**ON-SITE SEWAGE DISPOSAL SYSTEM
 HOWARD COUNTY HEALTH DEPARTMENT
 BUREAU OF ENVIRONMENTAL HEALTH**

SUBDIVISION: Walnut Springs LOT NUMBER: 21

ADDRESS: 1213 Emmaus Road PROPERTY OWNER: Mal Ja Baek

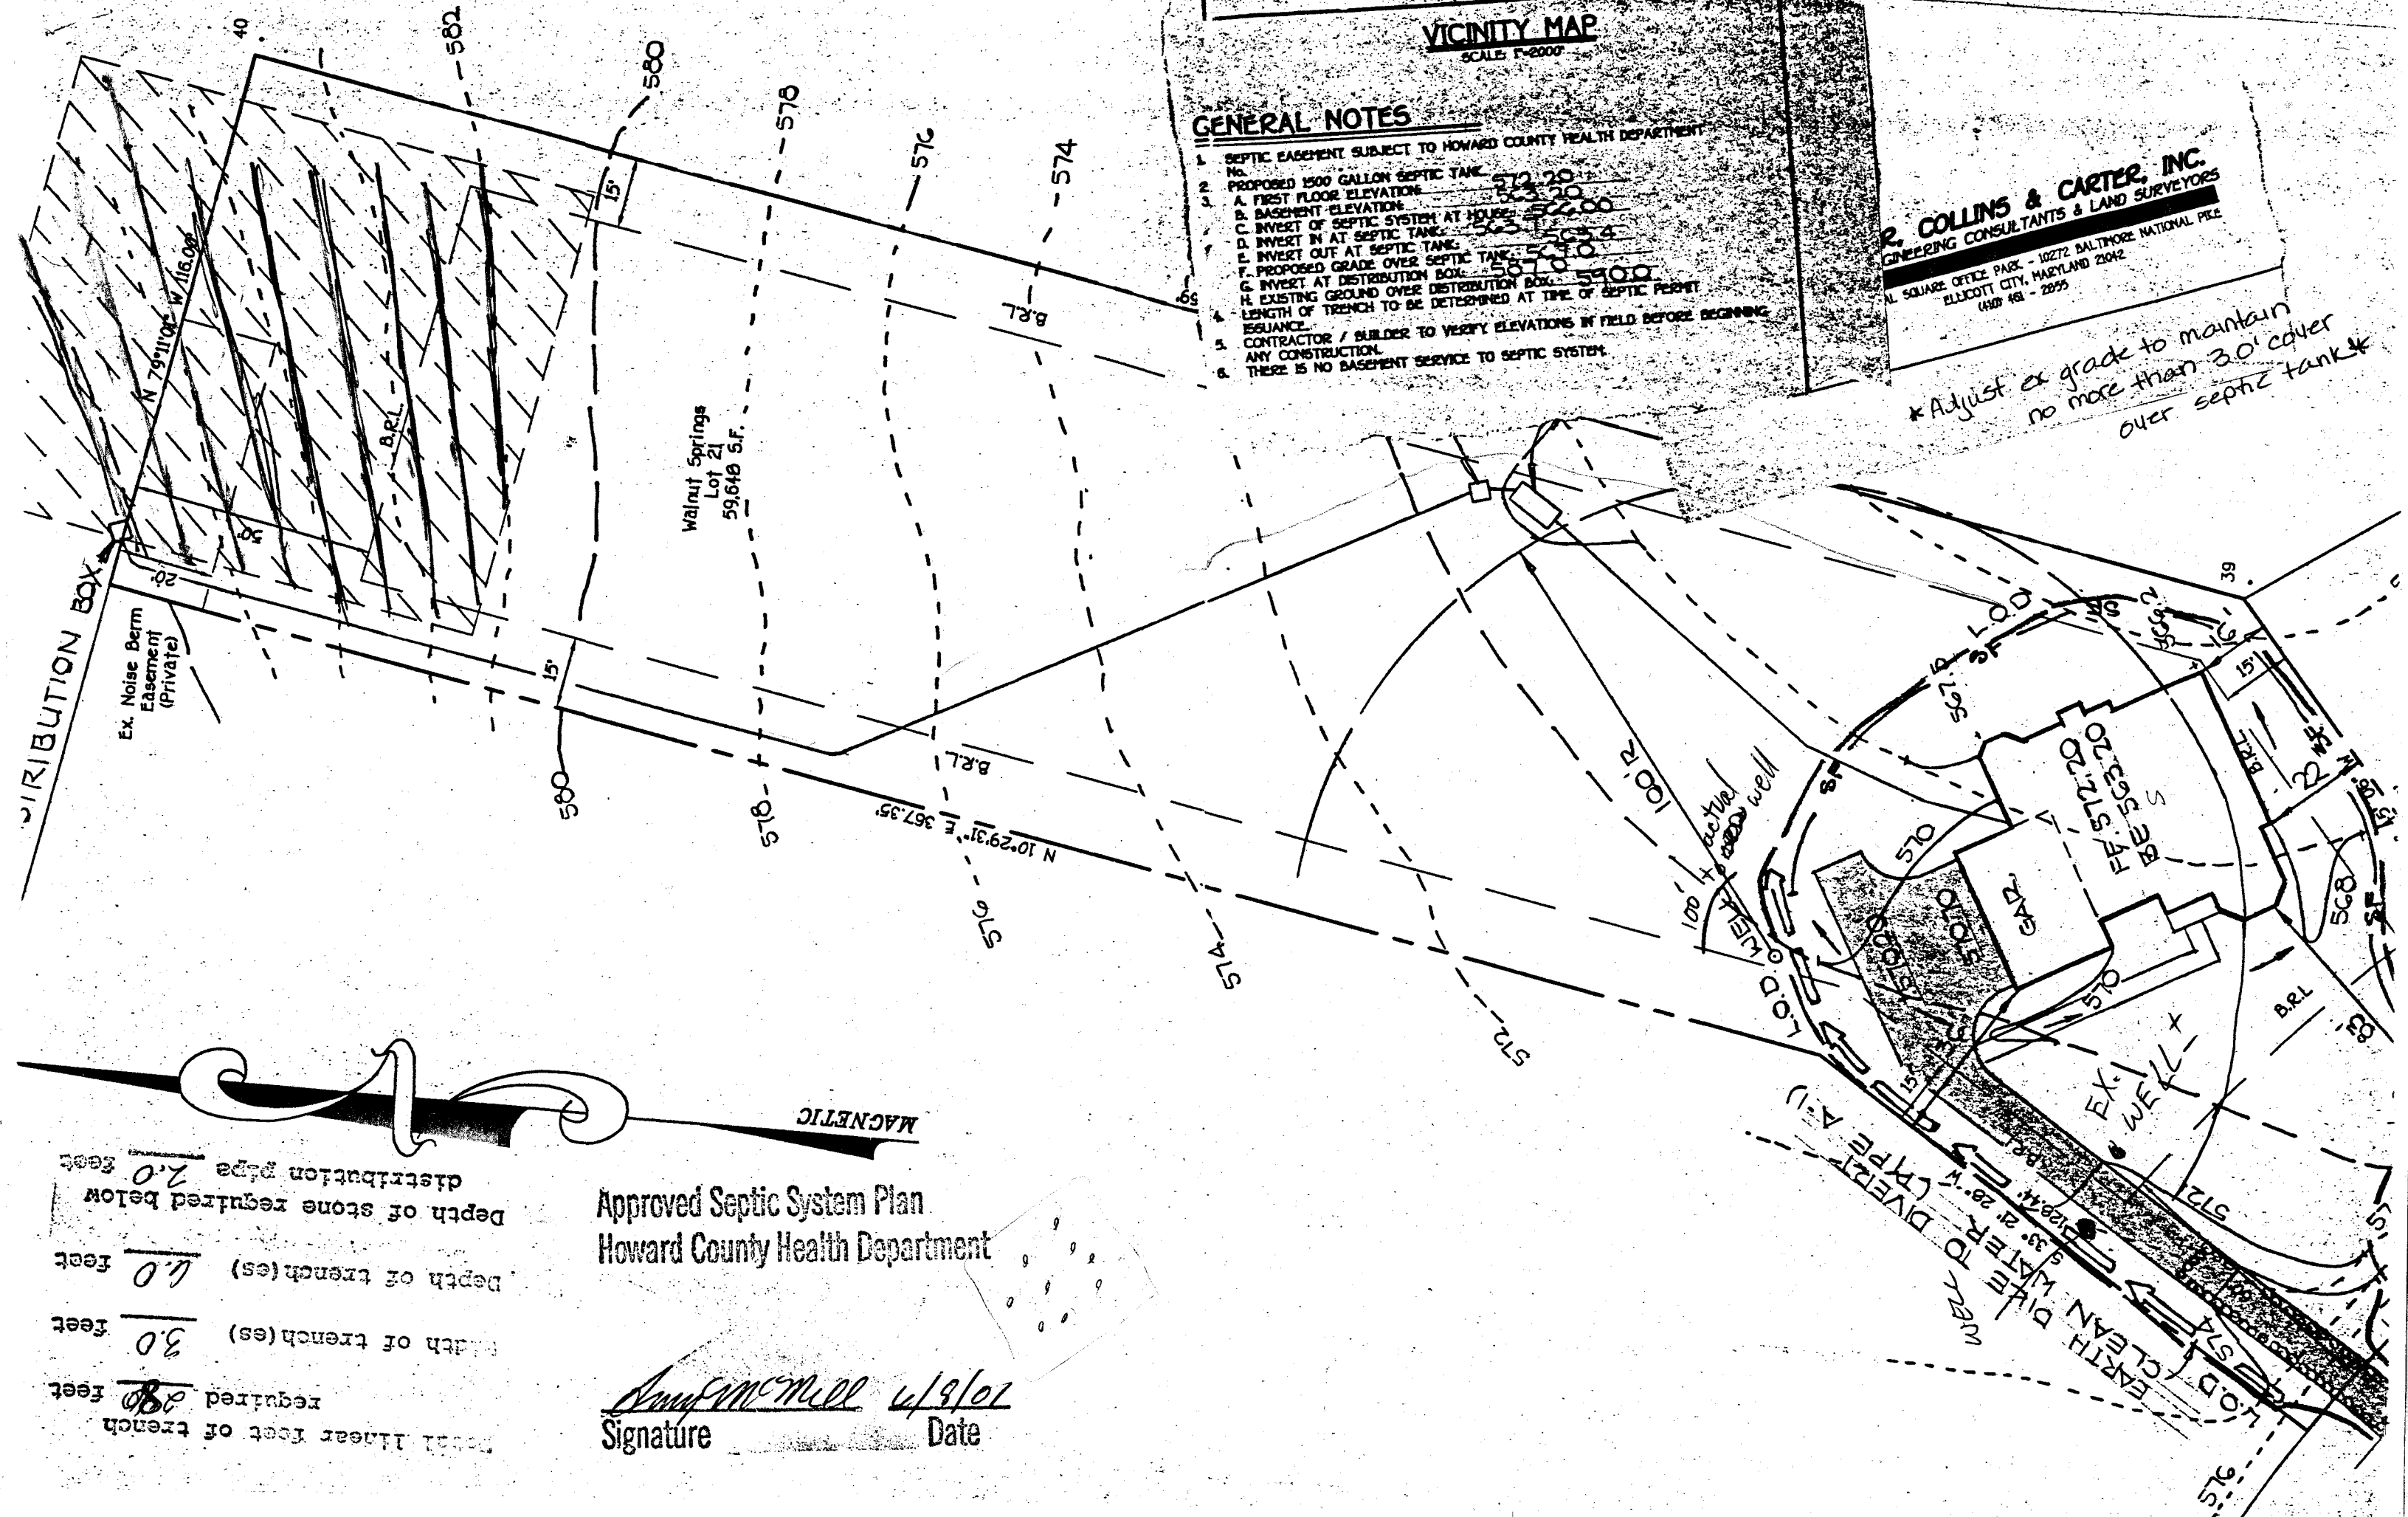
PRE-CONSTRUCTION INSPECTION: 1/16/02 First trench to be placed as high as possible in easement - will cut into part of noise berm. This inspection comments: will insure at least 1 repair before a system has to be installed in noise berm. Trenches 10' center to center. (BB)

1/17/02 - TANK HOLE DUG^(A), WATER AT 6-7', MOTTLING INDICATING REDOXIMORPHIC CONDITIONS AT 2' & BELOW OBSERVED - (SRK) 1/18/02 - 2ND TANK HOLE DUG AT HIGHER & SHALLOWER LOCATION (SEE SOIL PROFILE ON OTHER SHEET & PICTURES) OK TO SET TANKS IN THIS LOCATION w/ LID NO DEEPER THAN 65", ALL OPENINGS TO BE SEALED TO TANK (TARRED)

CONTRACTOR TO ALSO CUT SWALE & GRADE TO DIVERT WATER AROUND & AWAY FROM TANKS TANKS SET, SEAM LOCATION OK (HIGH ENOUGH ABOVE MOTTLES), OK TO COVER TANKS & TOP TRENCH

- 1/22/02 - OK TO COVER ALL WORK, PUMP & ALARM TEST STILL NEEDED (SRK)
- 5/28/02 Pump test failed, pump appears to be too small. Alarm box not hooked up (SRK)
- 5/29/02 D.B dug up, Pump test OK Alarm OK (SRK)

TANK HOLE

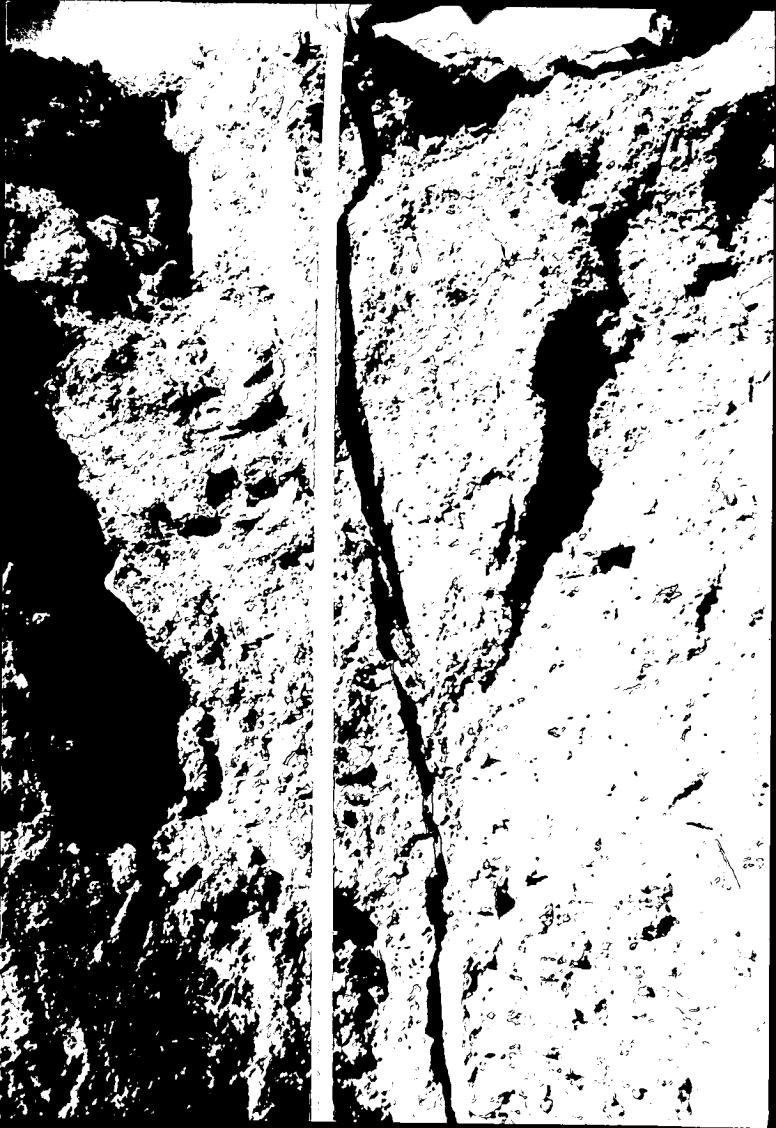
SEPTIC & PUMP TANK HOLE = Perched Water Table
